Permit Type	Permit Number	Opened Date
Building/Residential/Alteration/SFD	B26001054	04/07/2026
Description of Work		
SFD/ SECOND FLOOR ALTERATIONS TO REMOVE AND ADD WALLS TO REVISE LAYOUT AND ADD A PRE-FAB ADDITIONAL SET OF STAIRS FROM SECOND FLOOR TO THIRD FLOOR TO REPLACE EXISTING PULL DOWN STAIRS

McLain Permit questions:

PROJECT DESCRIPTION:
MCLAIN 2ND FLOOR PROPOSED PLAN V8.1

PROJECT DESCRIPTION:
 MCLAIN 3RD FLOOR PLAN

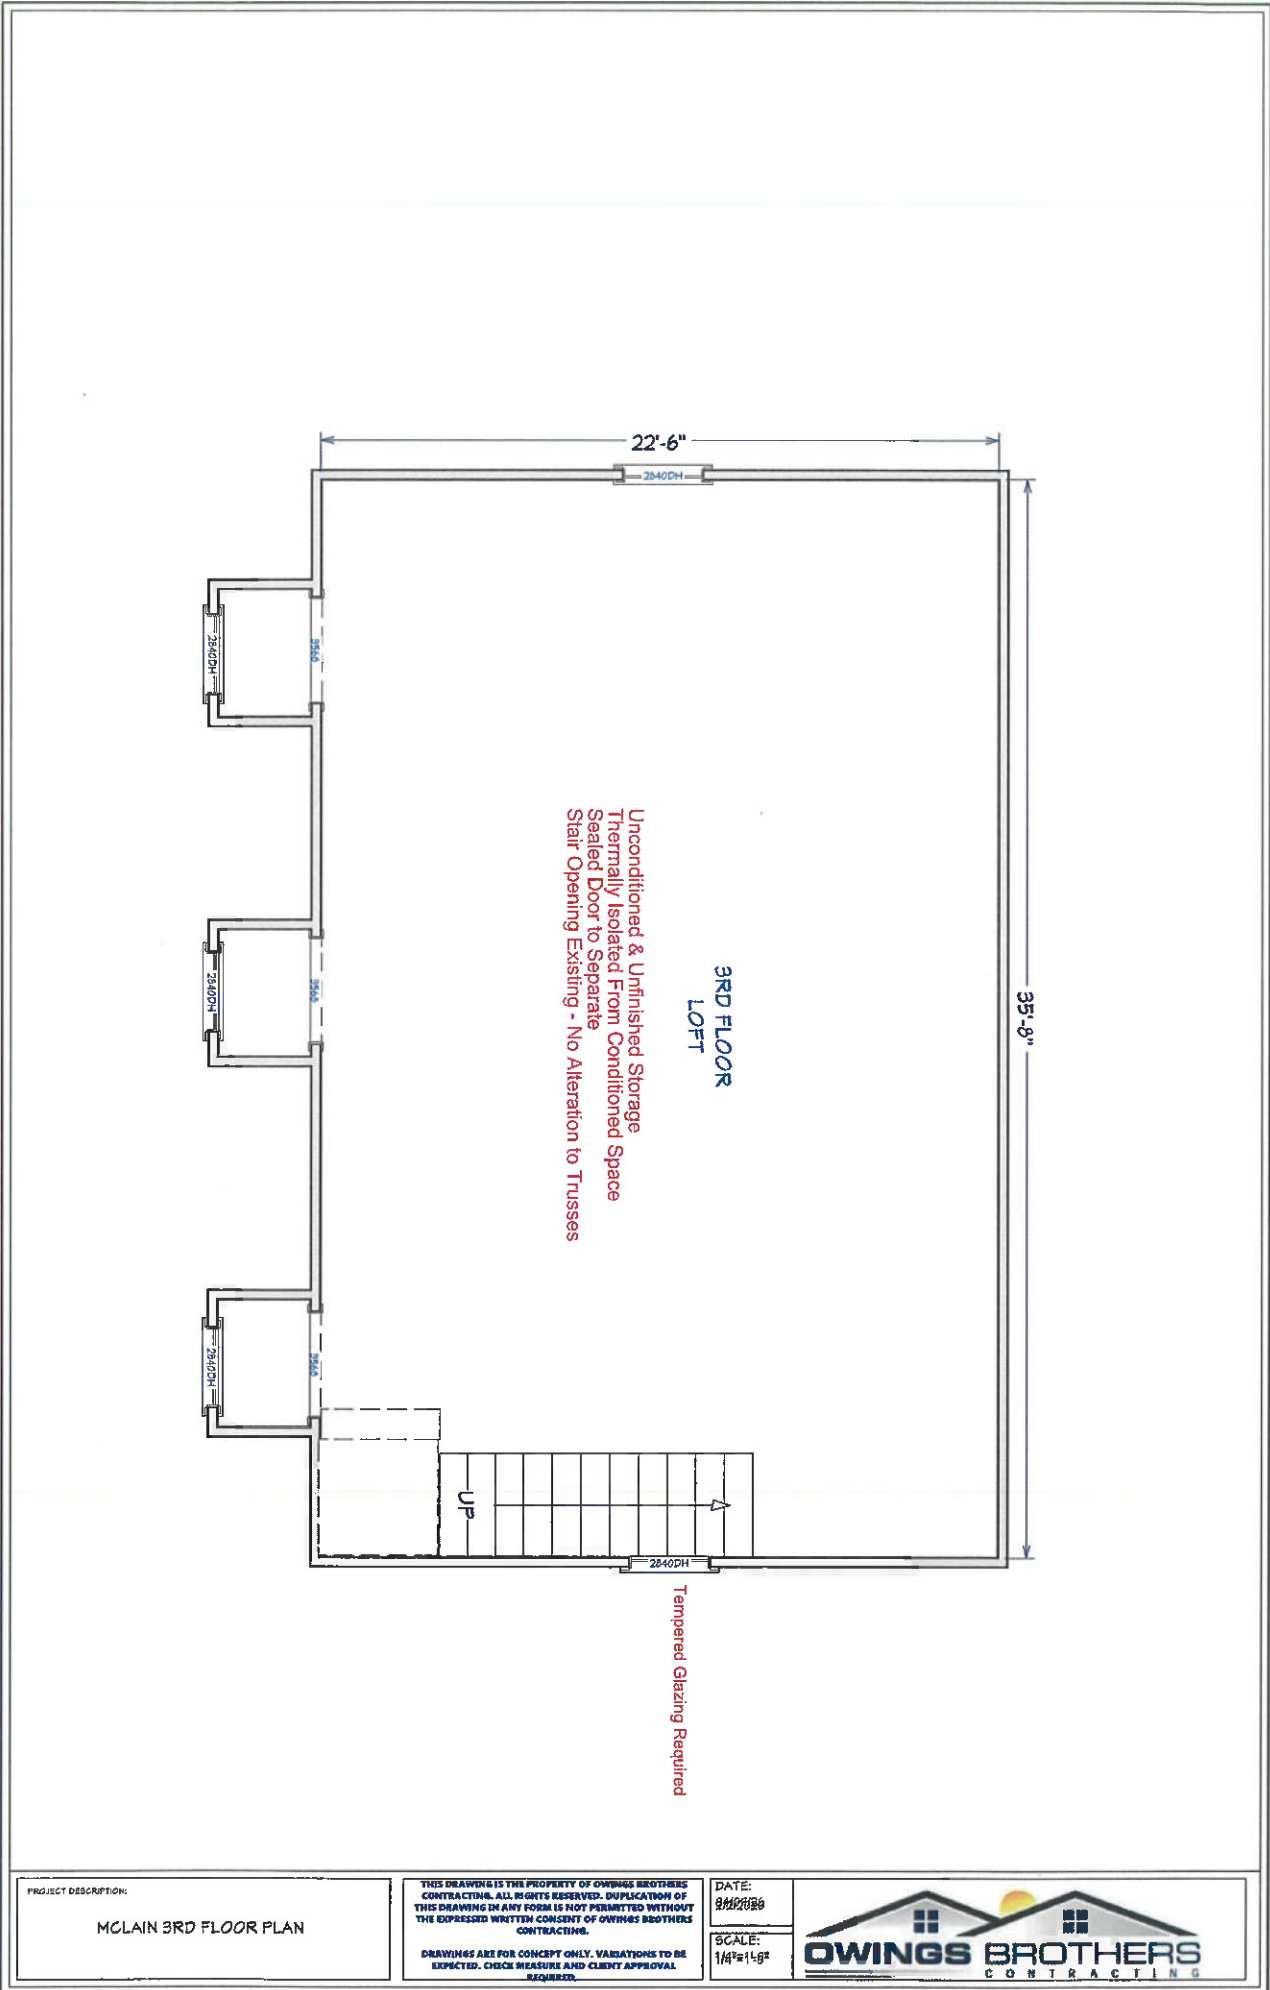
Windows adjacent to stairways and landings are required to have tempered glazing. **Existing window will be laminated and certificate on site.**

2nd Floor Alterations: Non Bearing Walls, Existing Trusses above

Tempered Glass Required

**REVIEWED FOR CODE COMPLIANCE
DEPARTMENT OF INSPECTIONS LICENCES
AND PERMITS HOWARD COUNTY
BY: Michael Blevins
SUBJECT TO FIELD INSPECTION**

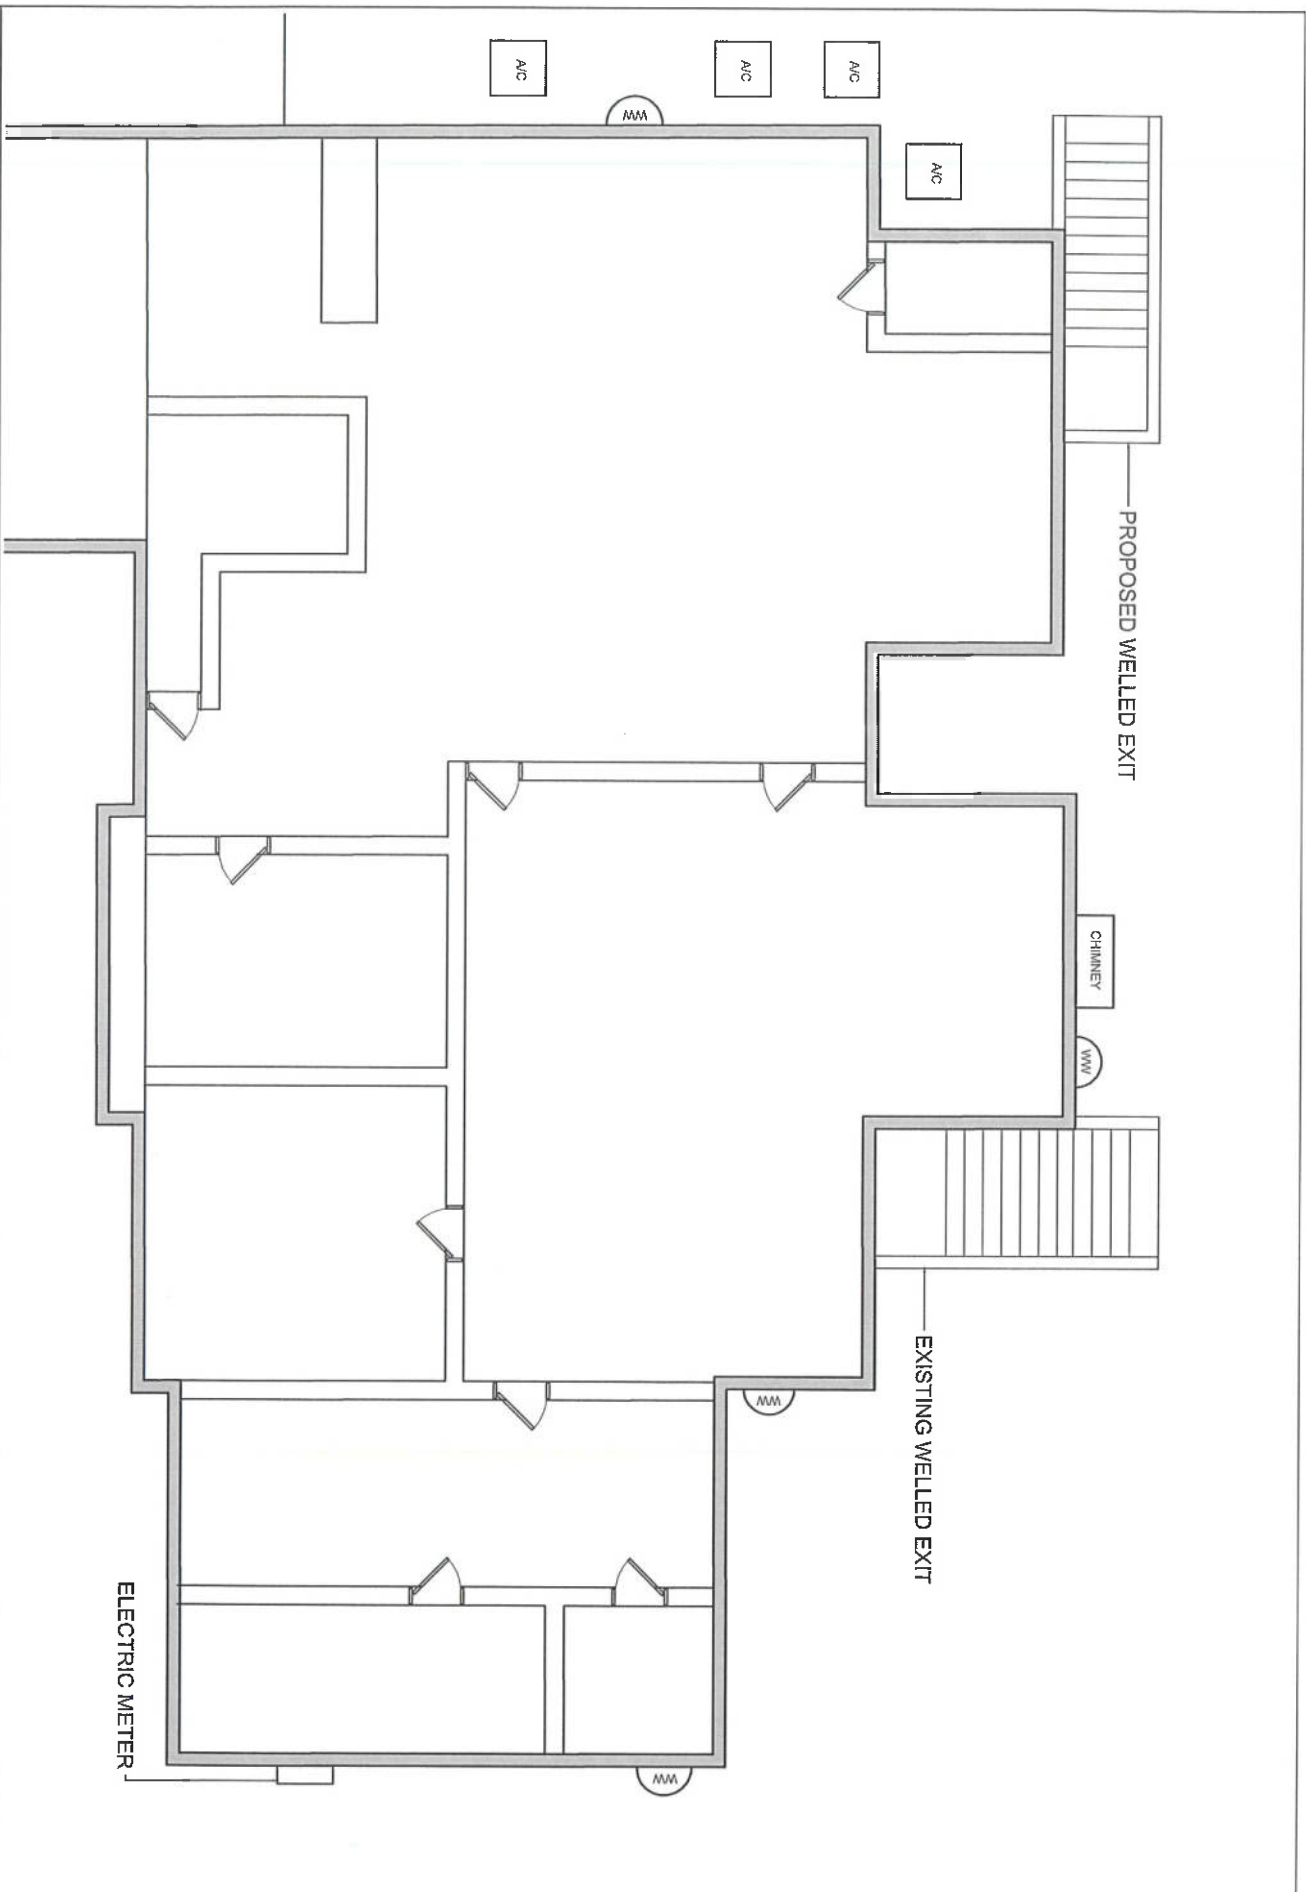
Trusses and Rafter framed roofs are typically spaced 24"oc or less. Provide Framing drawings showing how the loft floor will be modified to accommodate a 42" wide stairway. If trusses are modified an Engineers signed and sealed detail is required. **There was an existing framed opening for a future stairway. This was laid out when the house was originally framed. We are installing the stairs only. Ceiling is 8'**

Will the loft be finished space? What is the ceiling height? **Unfinished with door located at top of stairway. 8' ceiling**

Now that the loft is open to the 2nd floor by the stair way it is required to meet energy code. Current Energy Code is the 2024 IECC. The link below shows the Required Prescriptive R values in the orange table. Energy Credit are not required for this. **This will not apply as we are isolating the third floor as an unfinished space. Anything in stairway will be brought up to energy code.**

Unconditioned & Unfinished Storage
 Thermally Isolated From Conditioned Space
 Sealed Door to Separate
 Stair Opening Existing - No Alteration to Trusses

Tempered Glazing Required
